March 1986

Technical Evaluation Report of
1984 Meteorological Data from
the Donald C. Cook Nuclear
Power Plant

Submitted by: Gregg L. Andrews
Battelle Pacific Northwest Laboratories
P.O. Box 999
Richland, WA 99352

Figure 1.
(from Donald C. Cook 1971)

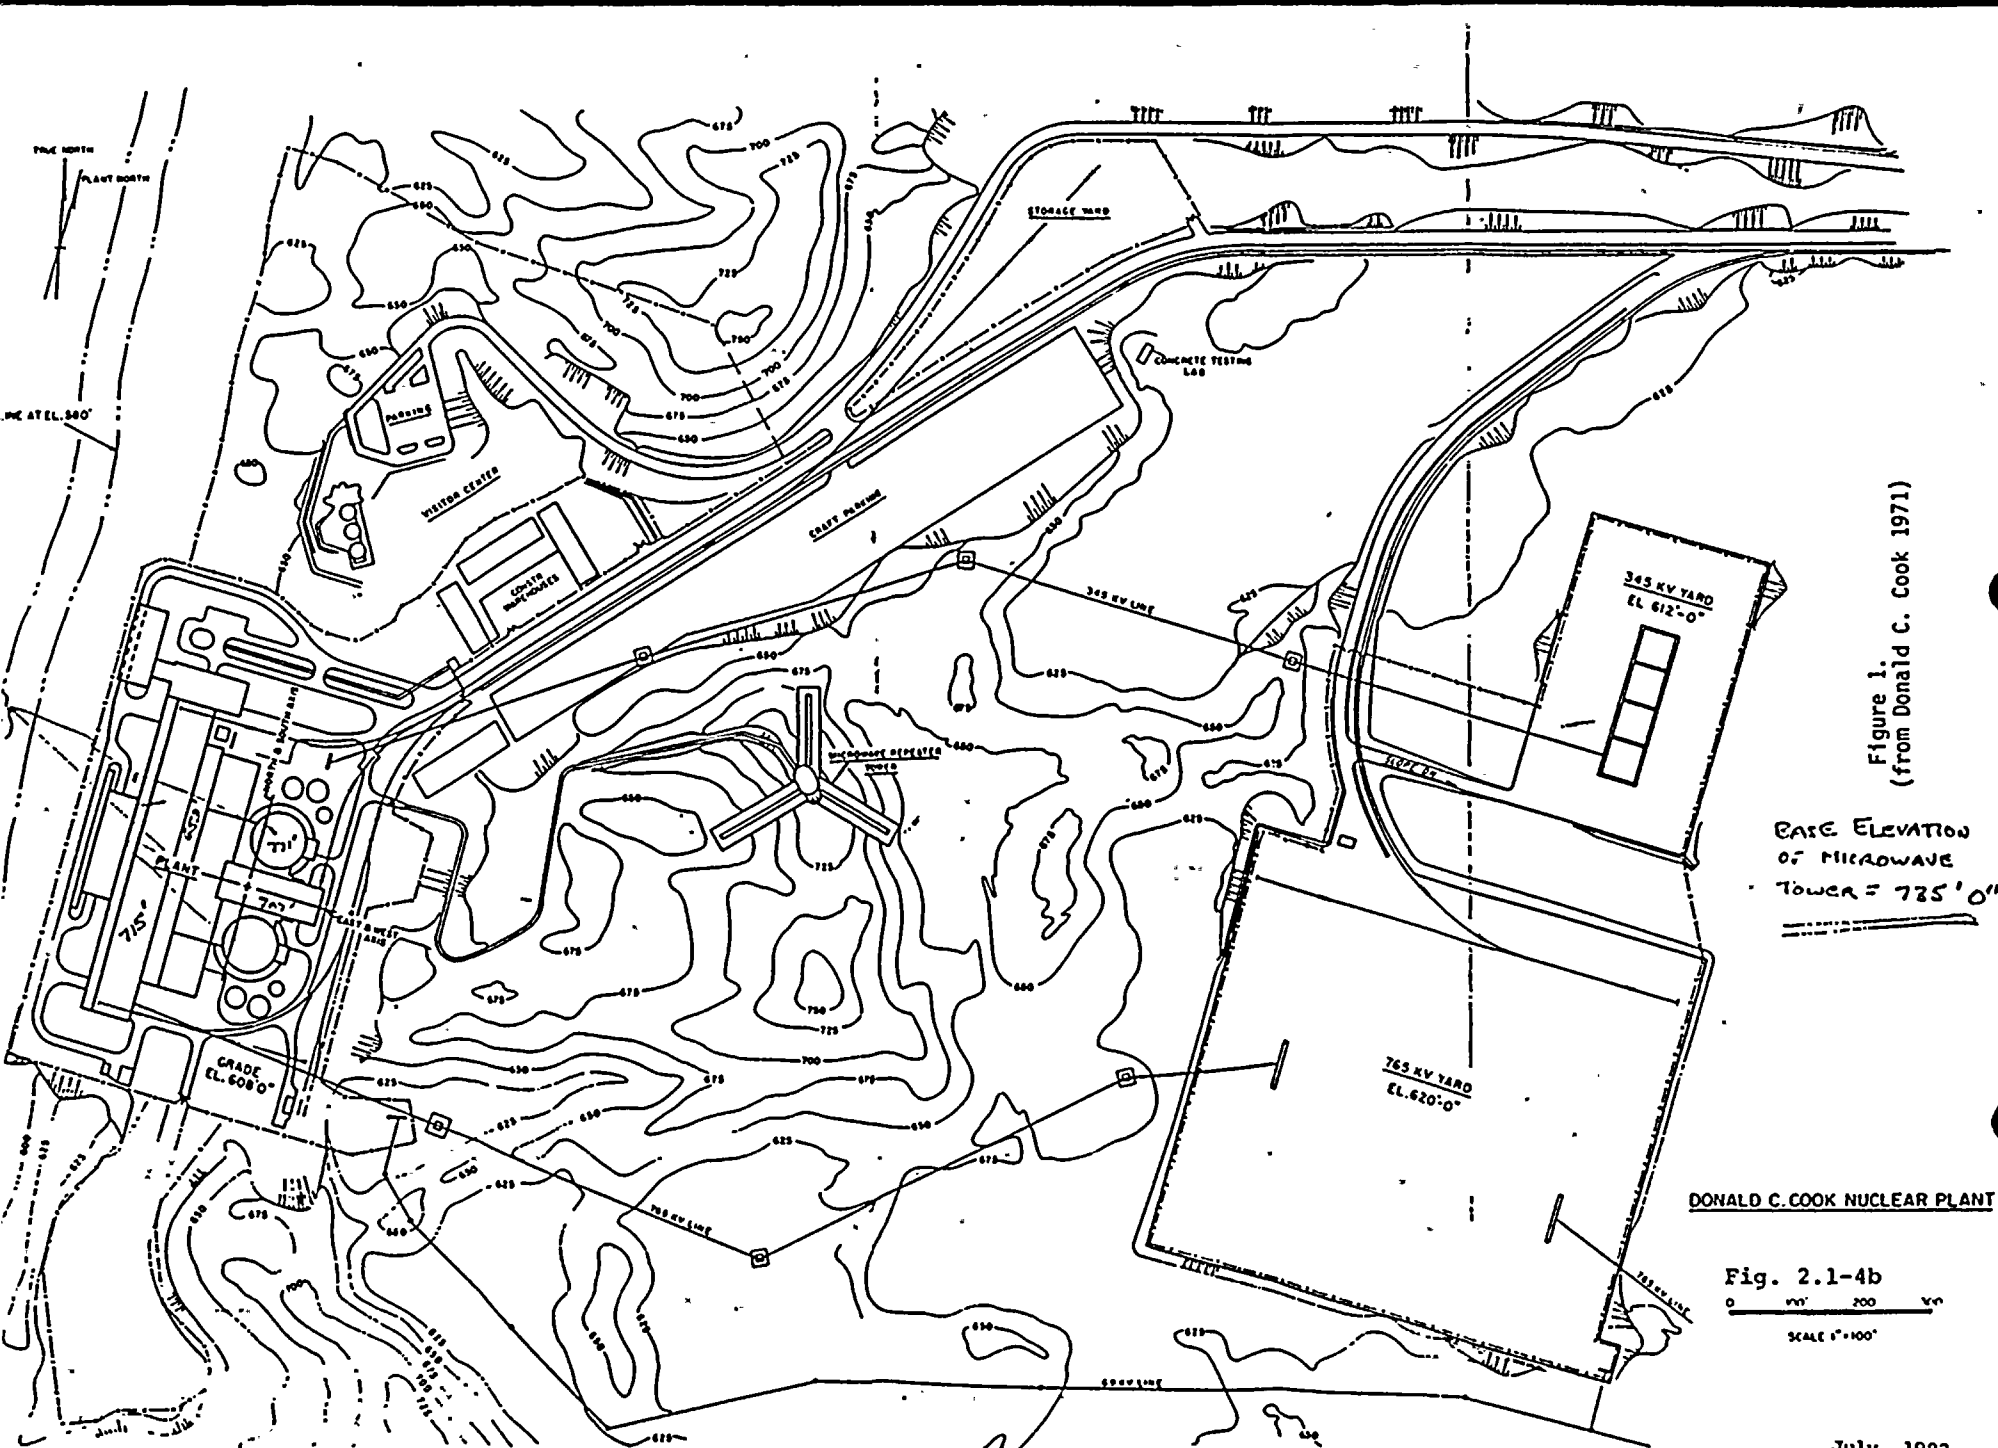
Onsite meteorological measurements are made on a 60.9 meter microwave repeater tower located approximately 107 meters east-northeast from the containment buildings (Fig.1). The tower is elevated with respect to the plant buildings. The tower base elevation is about 220 meters MSL while the top of the containment buildings are 235 meters MSL. The immediate area surrounding the tower is dominated by rugged sand dunes.

The meteorological tower at D. C. Cook is located in a unique setting. Rugged sand dunes covered with vegetation surround the immediate area of the tower while the terrain slopes toward Lake Michigan just west of the tower. However, the sand dunes do not extend to the site boundary in most directions or to locations further inland. The tower is located approximately 107 meters west of the containment buildings. The elevation of the top of the buildings are approximately 15 meters above the base elevation of the tower. Considering these factors and some basic meteorological principles suggests that the wind data are probably affected by building wakes and surface friction as discussed in subsections 4.2.3 and 4.2.4. For example, this influence is seen in the comparison between the 15.2 meter and 45.7 meter wind speed in Figure 6. A large difference is evident in the 5.0-10.0 m/s speed range, which suggests that there is an abnormally large increase in wind speed between the 15.2 meter and 45.7 meter level. Additionally, the Final Safety Analysis Report (Donald C. Cook 1971) from the D. C. Cook plant discussed the unrepresentativeness of the 15.2 meter level wind speed on the main tower. This conclusion was based on a study which compared the 15.2 meter level wind speeds on the main meteorological tower to 15.2 meter level wind speeds from a satellite tower location two miles east of the main tower where terrain is flat. Table 3 shows the comparison between wind speeds from the 15.2 meter level and 61.0 meter level on the main tower and the 15.2 meter level on the satellite tower. Wind data from the 45.7 meter level on the main tower was not included in the comparison. The wind speed is shown as a function of turbulence class where turbulence classification I indicates very unstable conditions and turbulence classification IV indicates very stable conditions. The period of data is not specifically stated in the FSAR, but the report does mention that the data presented were taken over a three year period sometime between 1966 and 1968.

Figure 2

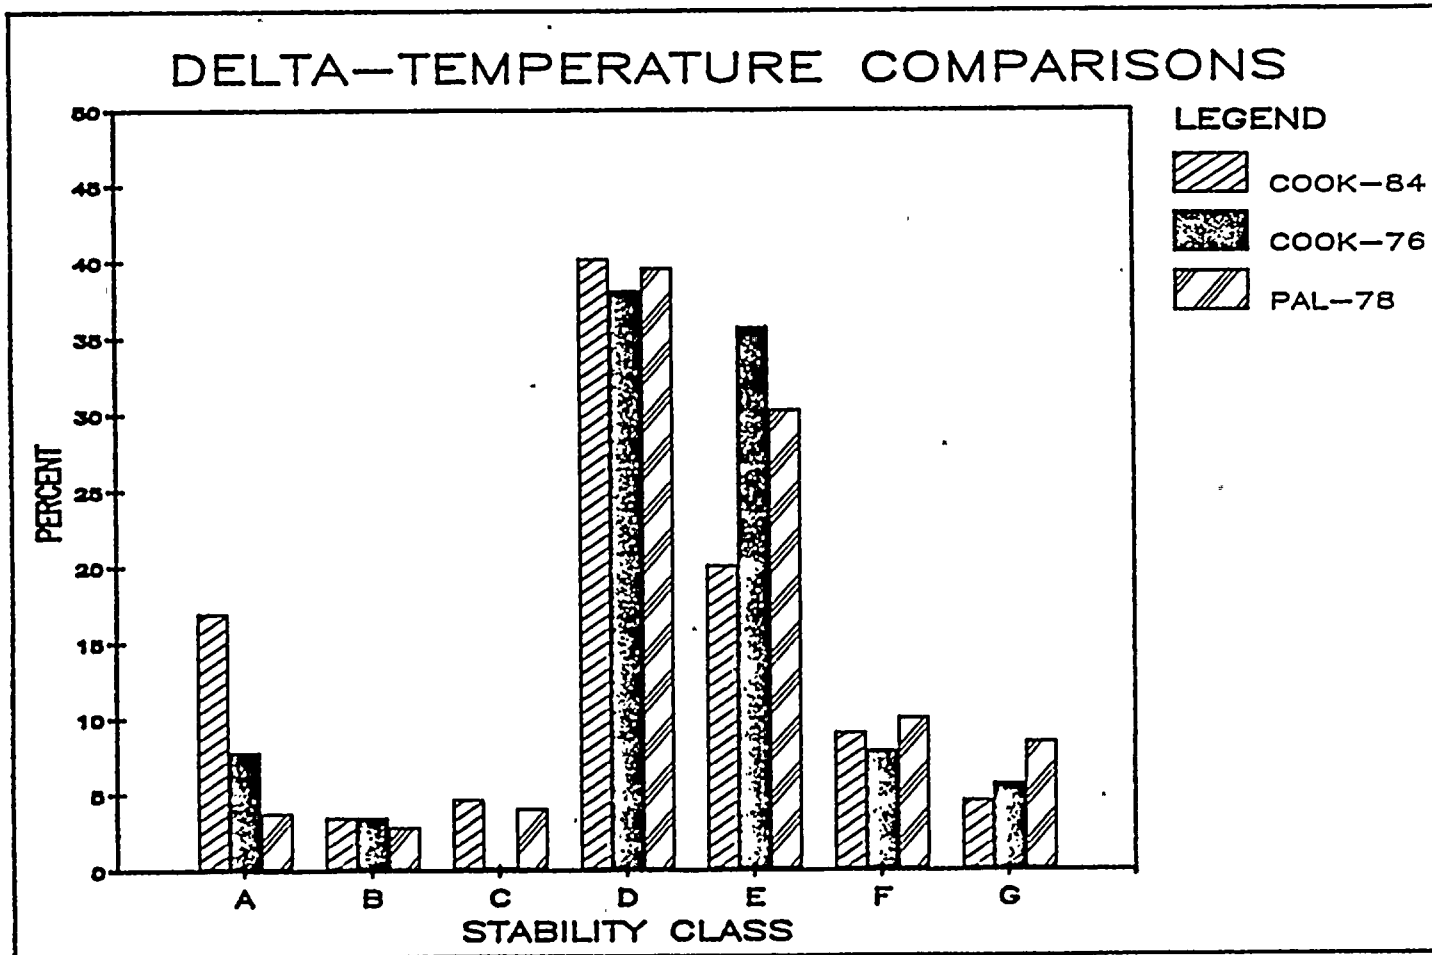
The 1984 D. C. Cook delta-temperature values were compared with previous (5/75 through 4/76) site data and previous (12/77 through 11/78) delta-temperature data from the Palisades nuclear site (Fig. 2). All data sets calculated the stability class using the delta-temperature method. The D. C. Cook delta-temperature is measured between the 54.9 meters and 9.1 meters and the Palisades is measured between 60.0 meters and 10.0 meters.

The 1984 D. C. Cook delta-temperature compares well with the other data sets except in the A and E stability class category. The QA program provides some insight into this peculiarity. There were a large number of A stability class occurrences during the months of May, June, July, August, and September when the local lapse rate (i.e. delta-temperature) exceeded the autoconvective lapse rate. The autoconvective lapse rate is defined as $-3.4^{\circ}\text{C}/100\text{m}$ in the QA program. A closer inspection of these occurrences show that they occur under onshore flow situations during daylight hours. Meteorological considerations suggest that this situation could produce very unstable (e.g. delta-temperature less than $-3.4^{\circ}\text{C}/100\text{m}$) conditions because the lower layers of the atmosphere would tend to heat rather quickly due to the surrounding sand dunes and vegetation while the upper layers of the atmosphere would remain cool due to the onshore flow. These conditions would yield a large vertical temperature gradient. The reason for the relatively low number of E stability class occurrences is not completely obvious. Further analyses (not within the scope of this report) are needed to determine if the low occurrences are related to local meteorology or instrument malfunction.

The 1984 D. C. Cook delta-temperature values and the 1976 D. C. Cook delta-temperature values appear to differ because of meteorological variations. Therefore, it appears the 1984 D. C. Cook delta-temperature values are probably climatologically representative for the shoreline environment. In addition, the data shows high reliability (98.8%). Although the delta-temperature values are probably reliable and representative of the local shoreline environment, the overall concern is whether the delta-temperature values represent atmospheric stability at the site boundary and locations further inland where populous areas may be affected by accidental or routine releases of radioactive material. Subsection 4.2.5 discusses this concern more thoroughly.

Figure 3

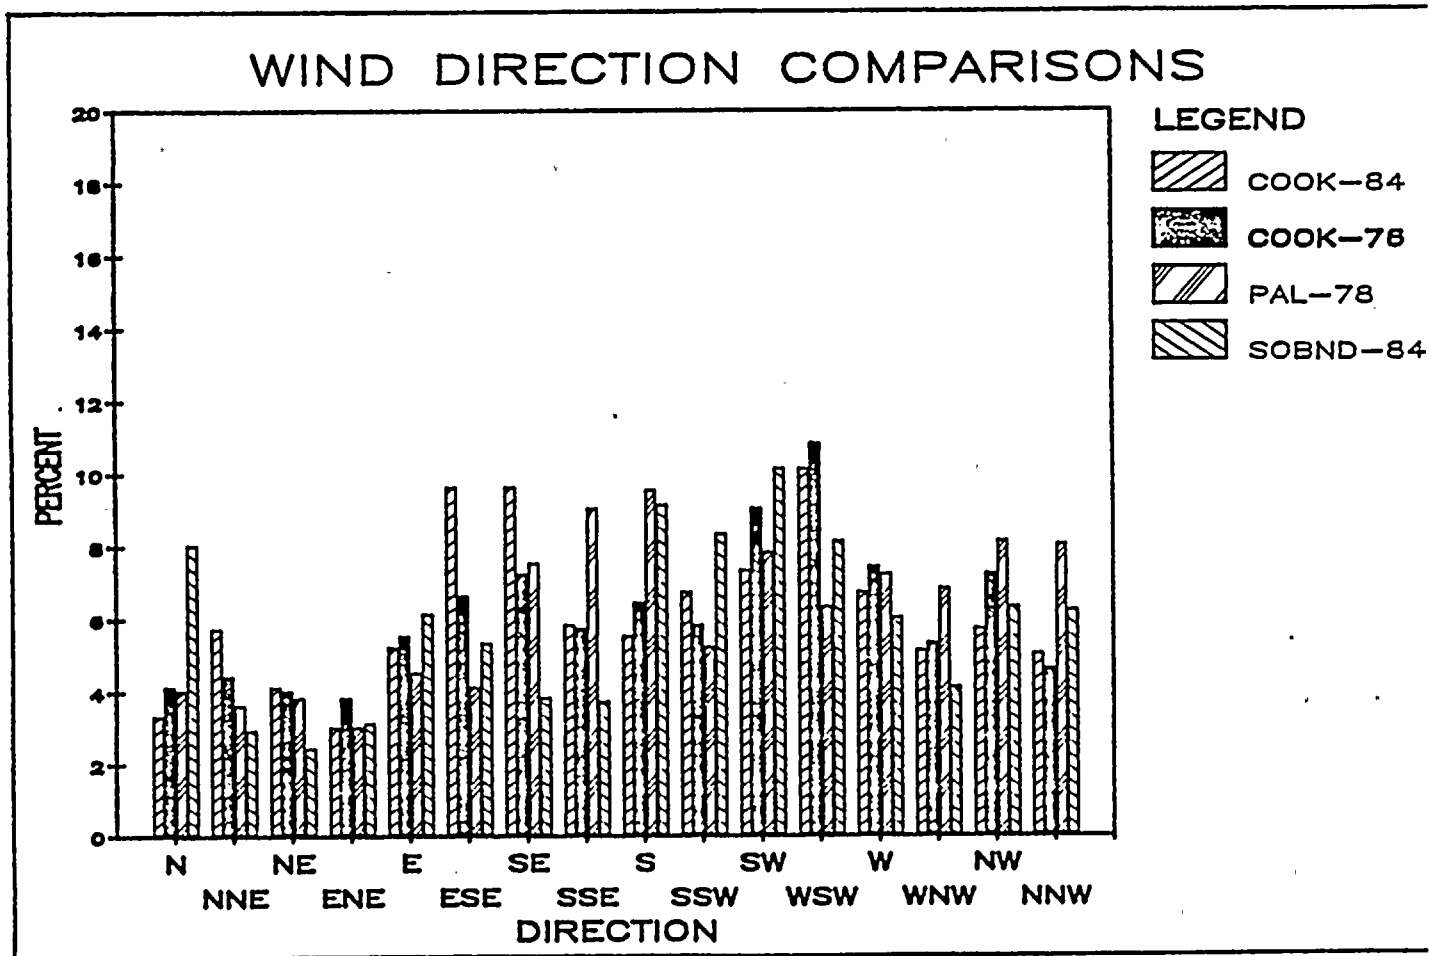
A comparison between wind directions from the 1984 D. C. Cook data set at 10 meters, previous (5/75 through 4/76) D. C. Cook data at 15.2 meters, previous (12/77 through 11/78) Palisades data at 10 meters, and 1984 South Bend data at 6.4 meters are shown in Figure 3. The comparison shows a reasonably close relationship among the different data sets, except in the north, east-southeast, and southeast sectors. These discrepancies are probably caused by the 15.2 meter wind direction responding to small-scale influences such as building wakes and local terrain (e.g., sand dunes). Consequently, the data are likely representative of the wind direction in the immediate vicinity of the sand

Figure 4

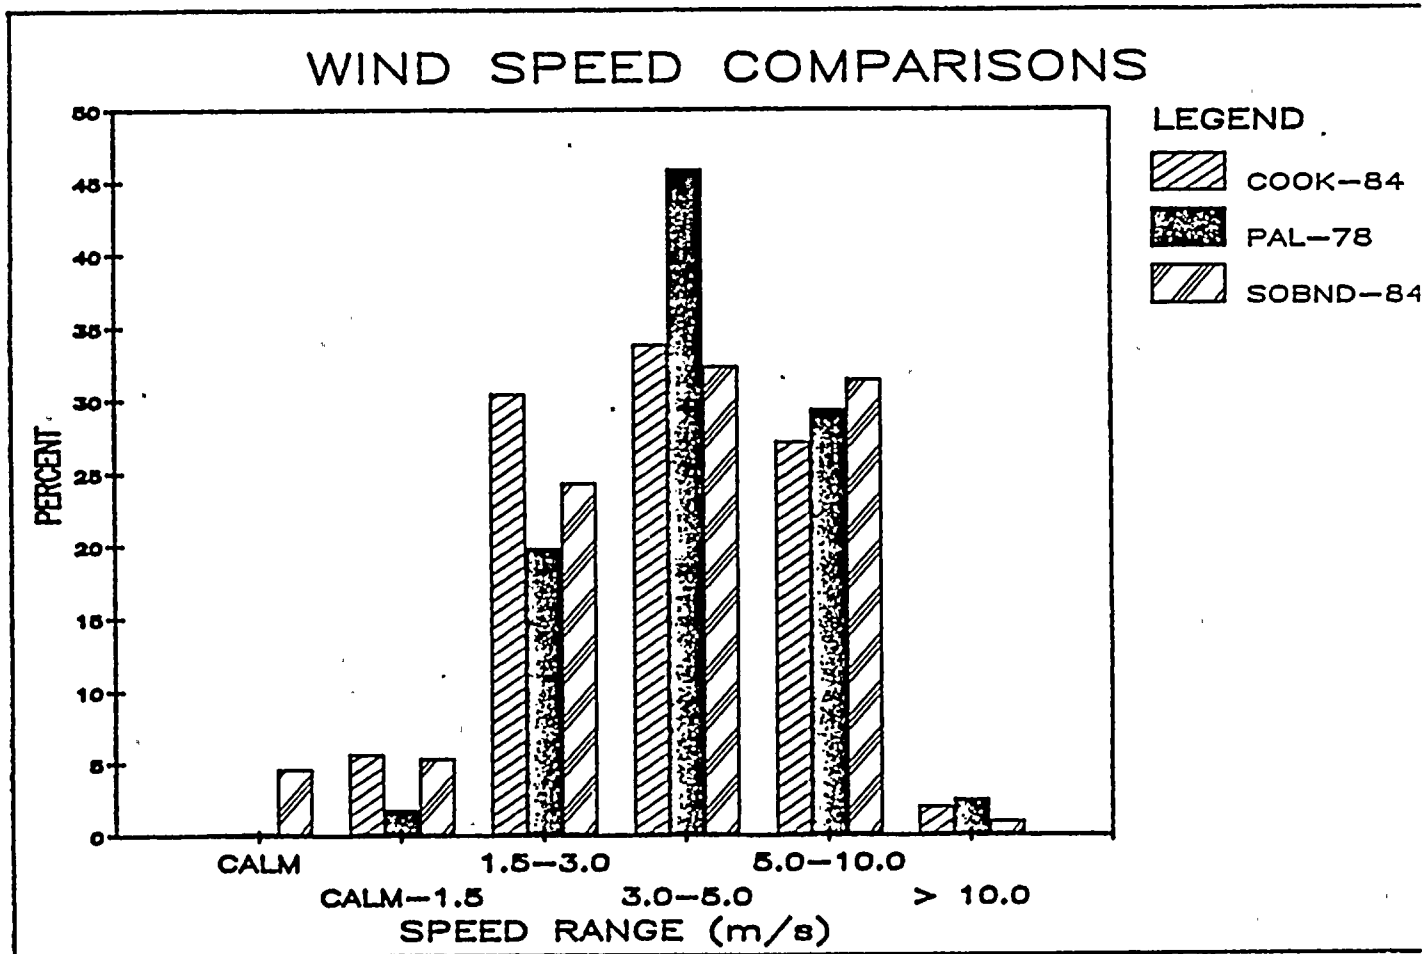
A comparison between wind speeds from 1984 D. C. Cook data set at 10 meters, previous (12/77 through 11/78) Palisades data at 10 meters, and 1984 South Bend data at 6.4 meters are shown in Figure 4. The previous D. C. Cook data (5/75 through 4/76) was not included because the wind speed categories did not coincide with the other data sets. There appears to be some variability within the data especially in the 1.5 - 3.0 m/s and 3.0 - 5.0 m/s speed ranges. A likely explanation for the variability would be local exposure problems because of small-scale influences such as building wakes and local terrain (e.g., sand dunes). It appears the 15.2 wind speed data at D. C. Cook is representative of the immediate environment, but probably not representative of conditions at the site boundary or locations further inland.

Figure 5

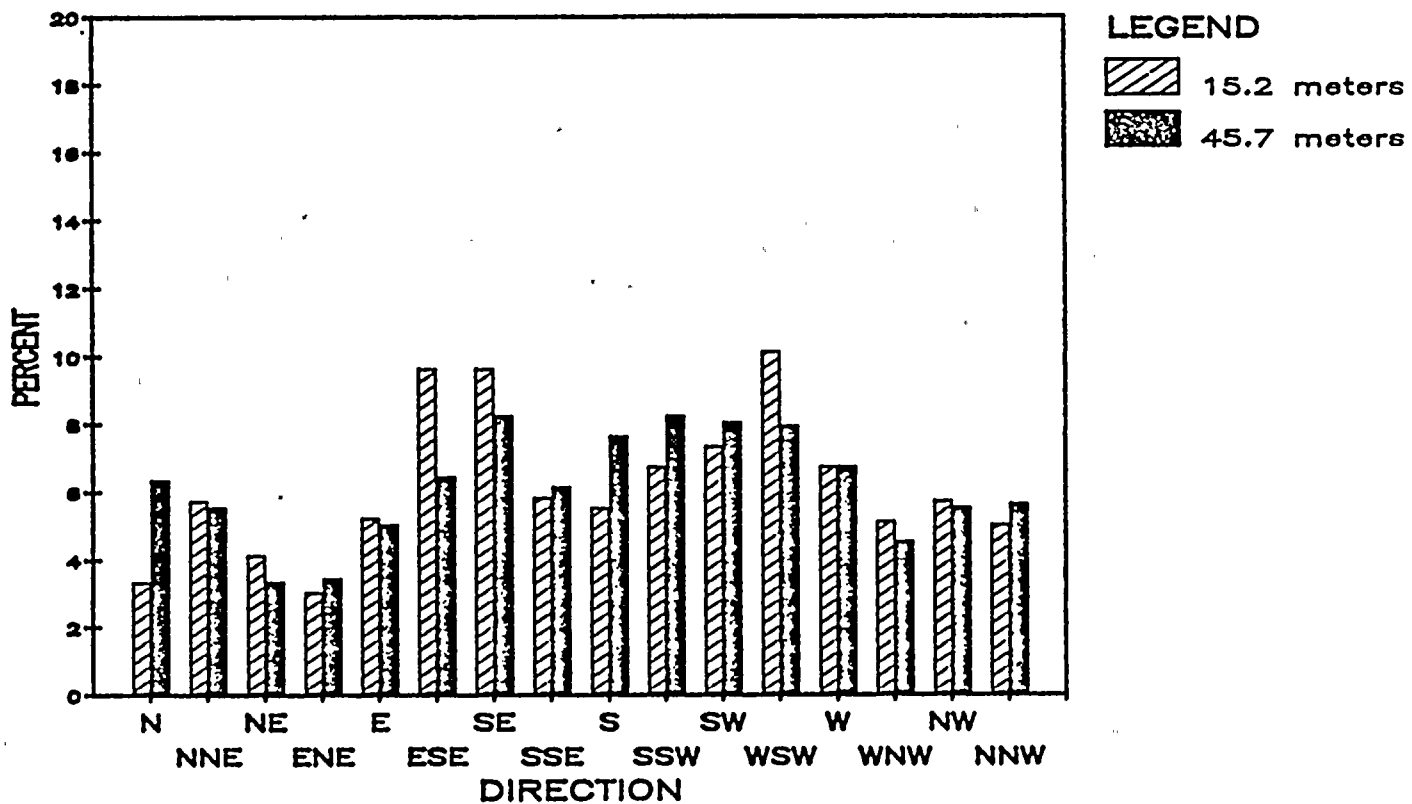
The 1984 D. C. Cook 45.7 meter wind speed data showed a high degree of quality and data reliability because of high data recovery (98.6%) and absence of spurious values. However, a comparison between the 45.7 meter wind direction and the corresponding wind direction data at 15.2 meters (Fig. 5) showed some differences in the north, east-southeast, south, and west-southwest sectors. A likely explanation for the discrepancies in those sectors is the effect from small-scale influences such as building wakes and local terrain rather than instrument malfunction. As with the 15.2 wind data, the 45.7 meter wind direction appear representative of the immediate area, but are probably not representative of site boundary or inland conditions.
